21 Deane Street

**APPLICATION FOR APPROVAL TO COMMENCE DEVELOPMENT - LOT 18 (21) DEANE STREET,  
COTTESLOE**

Development Application- #3112, 21 Deane Street COTTESLOE

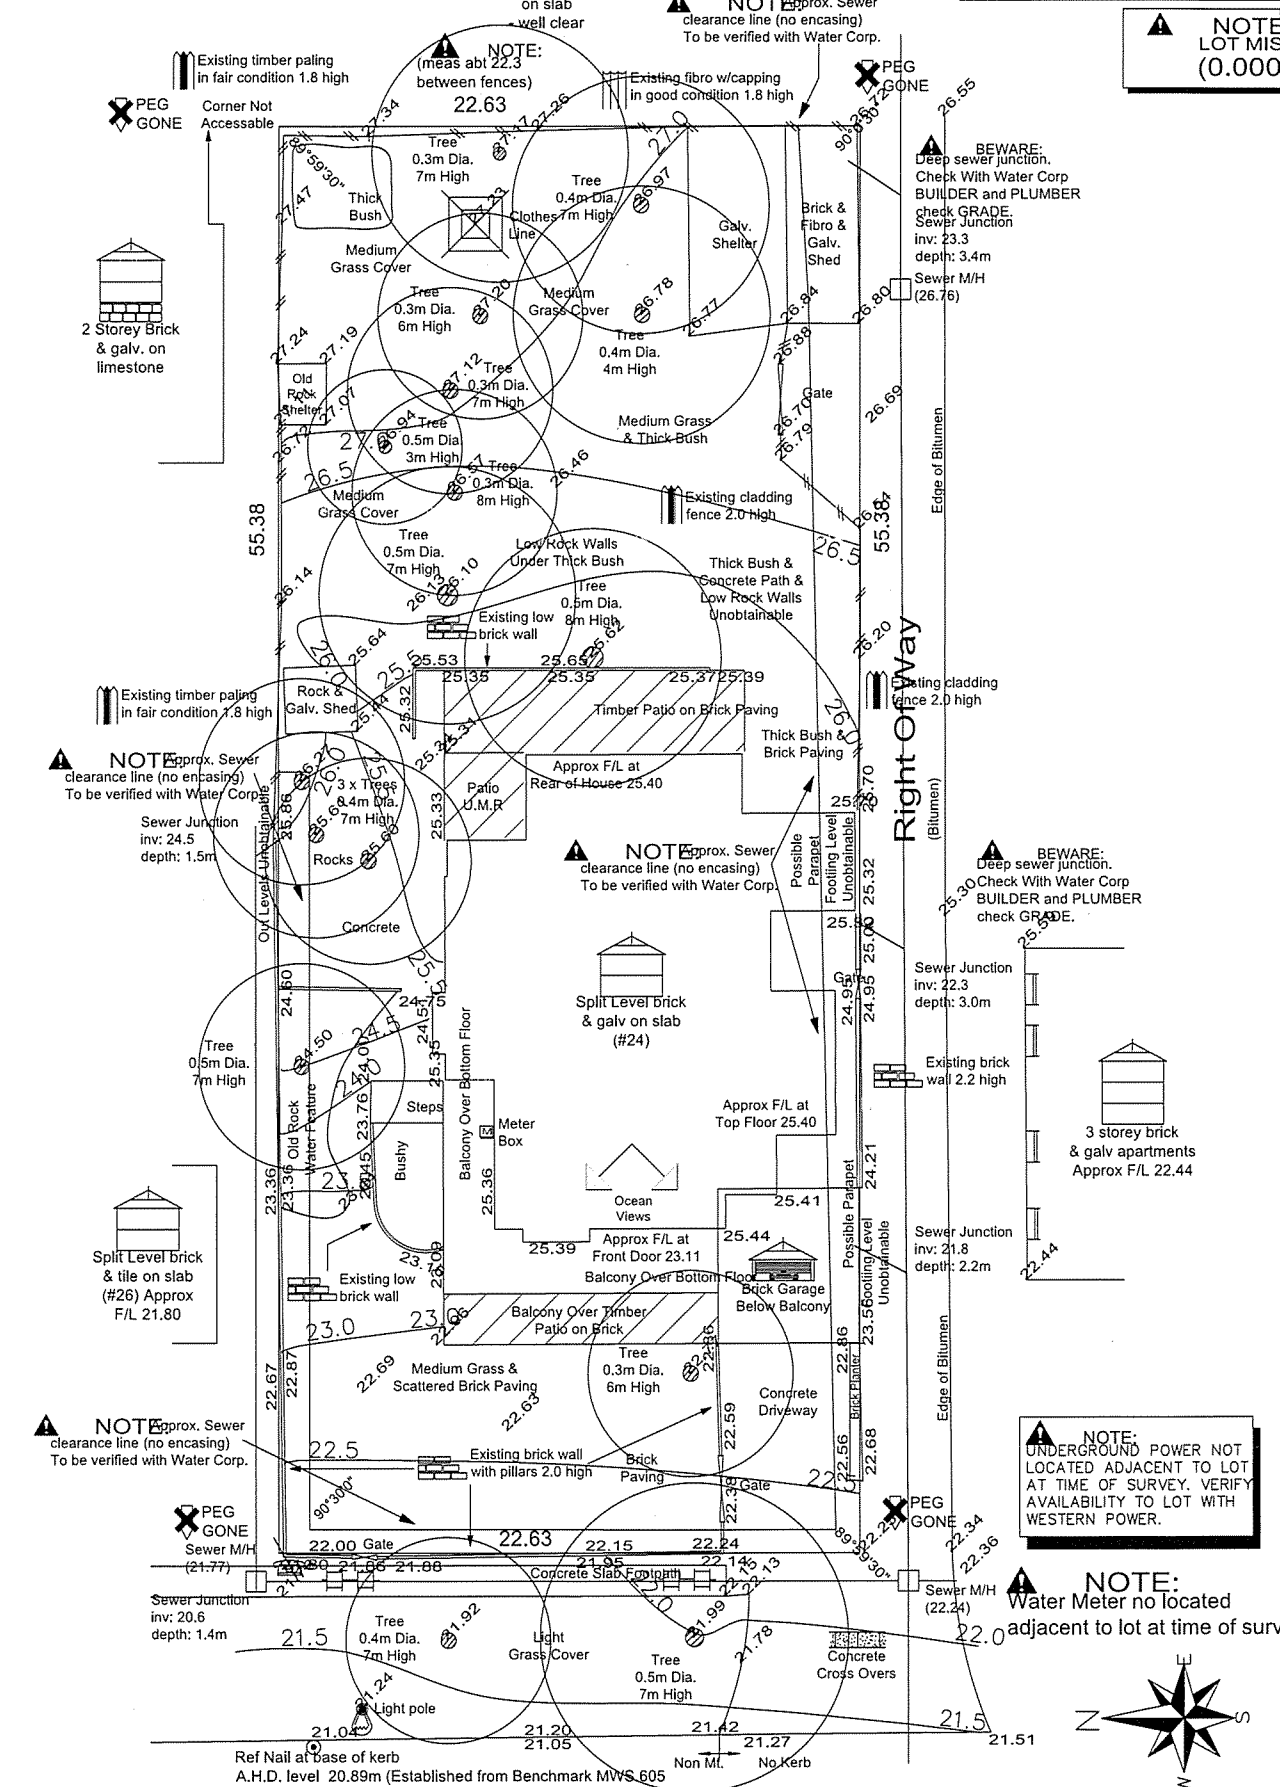
Further to our submission on 2nd August we have been able to find original survey information that shows the levels between 24 Avonmore and 21 Deane Street were originally **slightly lower** than the current levels on the western boundary of 21 Deane Street.

We note the levels on the licensed survey drawing show:

- Level of 26.72m on the southern end of the boundary at the ROW;
- Level of 27.26m to the midpoint of the boundary between 21 Deane and 24 Avonmore; and
- Level of 27.34m halfway between the midpoint and the northern point of the boundary between 21 Deane and 24 Avonmore

We therefore request that as the levels in the **attached survey drawing** are accurate to the nearest centimetre and have been undertaken by a licenced surveyor that **these be adopted as the NGL for the western boundary of the site.**

1 West  
 1 : 100

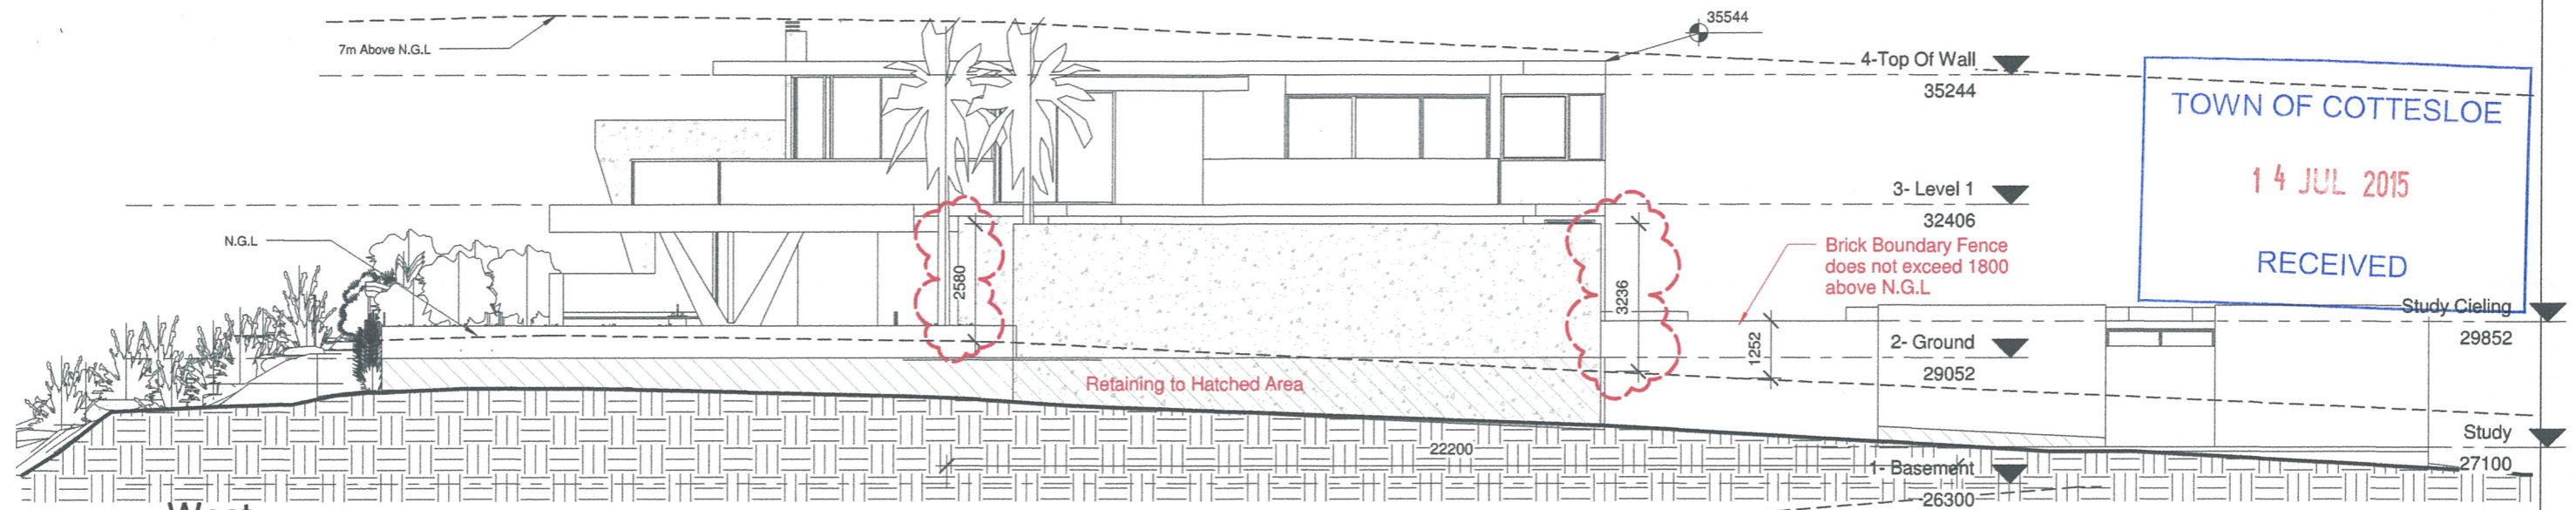
The owners **OBJECT to the proposed Development Application** at Lot 18 (21) Deane Street, Cottesloe, primarily in relation to the proposed height and setbacks on the western boundary. The owners are prepared to support revised plans for the site subject to satisfactory modification to the western elevation.

The proposed NGL of the site appears to be at or lower than the existing ground level. The physical context of the site and its surrounds clearly show that there is no basis to support a NGL higher than the existing ground level. The development should be assessed on an NGL for the western boundary that reflects the existing levels along the western boundary.

The impact of the proposed NGL is considerably higher than the walls to the western boundary. These proposed wall heights generate significant overshadowing and increase the general height and bulk of the proposal. The attachments show the existing courtyard outlook and the considerable negative impact the proposed development would have. It is clear that a development based on a 1metre minimum setback and lower building height would substantially reduce the impact on 24 Avonmore Terrace, without causing any need for the major modification of the proposed development of 21 Deane Street.

Whilst it is acknowledged the R30 code may allow nil setback walls, the Town Planning Scheme and the R codes have a range of broader amenity provisions that a nil setback wall would not satisfy in this location given the level differences between the two sites and the associated impact on natural light and ventilation of the properties. In any event the portions of nil setback wall exceed both the height and lengths that may be permitted under the R Codes.

- adoption of a **revised NGL no greater than the existing NGL walls on the western boundary** between the two properties and generally in accordance with the ground levels prior to the demolition of the previous house;

- all buildings **setback a minimum of 1m** from the adjoining portion of the western boundary of the proposed dwellings, or the greater amounts as required by Table 2a and 2b of the R Code relative to the length, height and openings. No use of clause 5.1.3 adjacent to the subject site on the basis it would not satisfy the broader amenity considerations of the R codes and the Town Planning Scheme;
